HOPEPOINT CHRISTIAN SCHOOL

# ACCESS DESIGN REVIEW – DEVELOPMENT APPLICATION (DA)

*Hopepoint Christian School, 42a Beale Street, Georges Hall NSW 2198*

Date: 5 June 2025

Figure 3: Building Access Diagram

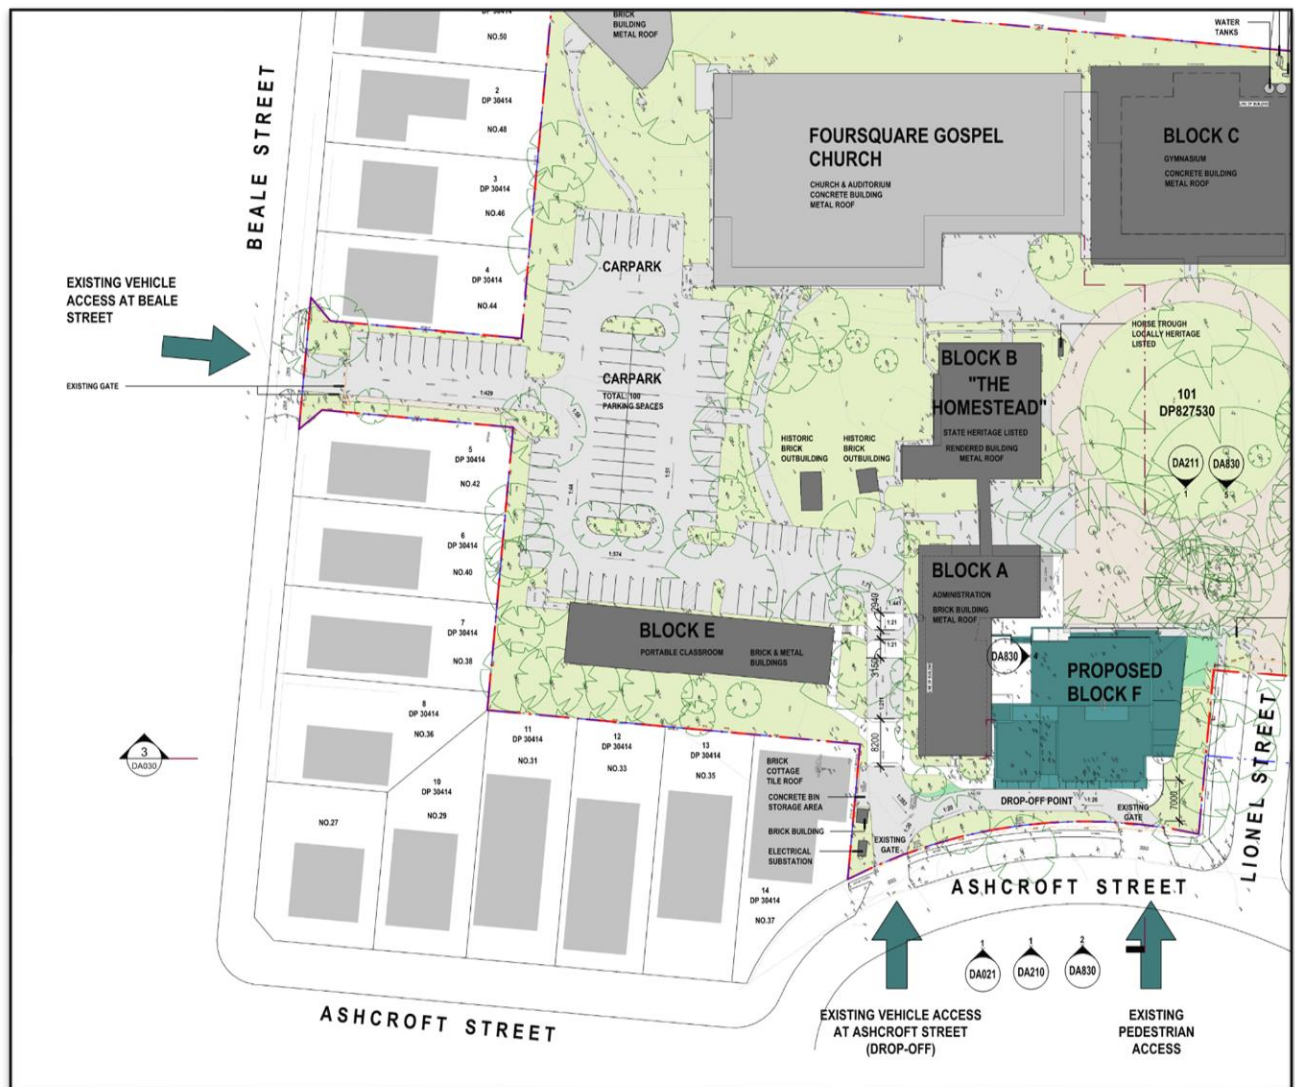
It has been confirmed that upgrade of the existing pedestrian entrance from the allotment boundary at Beale Street would not be viable as part of these scope of works and the pedestrian entrance at the allotment boundary of Ashcroft Street is to be upgraded to satisfy the requirements of the BCA. For further clarification, this is on the basis of Beale Street primarily used for vehicular access/egress and Ashcroft Street providing a greater degree of pedestrian movement and access into the school grounds as per the Traffic Impact Assessment Report completed by Bitzios Consulting. This is further supported by public transport stops being provided within close proximity of Ashcroft Street and the proposed School Bus Zone located on Ashcroft Street.

The proposed accessway from the pedestrian entrance at the allotment boundary to the building entrance of Block F complies with BCA Clause D4D3 and AS1428.1-2009.

Where Beale Street is used primarily for vehicular access, compliance is capable of being achieved from the accessible parking bays to the proposed Block F building entrance based on the noted gradients and proposed walkways. A delineated pedestrian accessible path of travel from the accessible parking bays to Block F has been provided via the accessible path linking Block E to Block F as well as the driveway from the accessible parking bays to Ashcroft Street (and Block F) which is graded between 1:21 at its steepest point.

Figure 4: Existing Accessible Parking Spaces Location

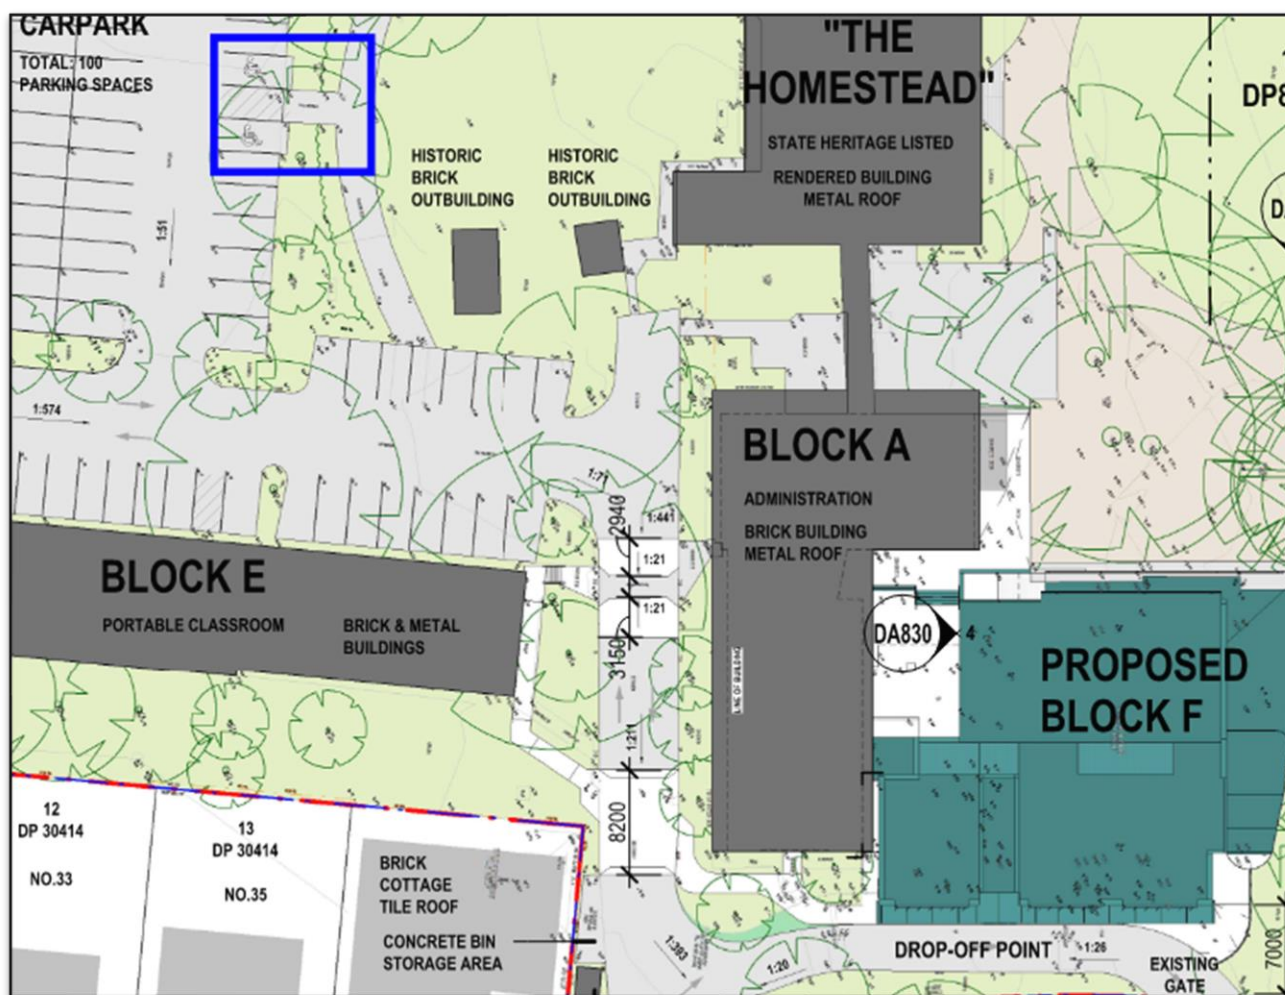
The existing carpark is identified two (2) accessible parking bays and shared zone to satisfy the carpark requirements of the BCA as marked up within the blue square within Figure 4 below.

No new works are noted on the Architectural drawings to the carpark area.
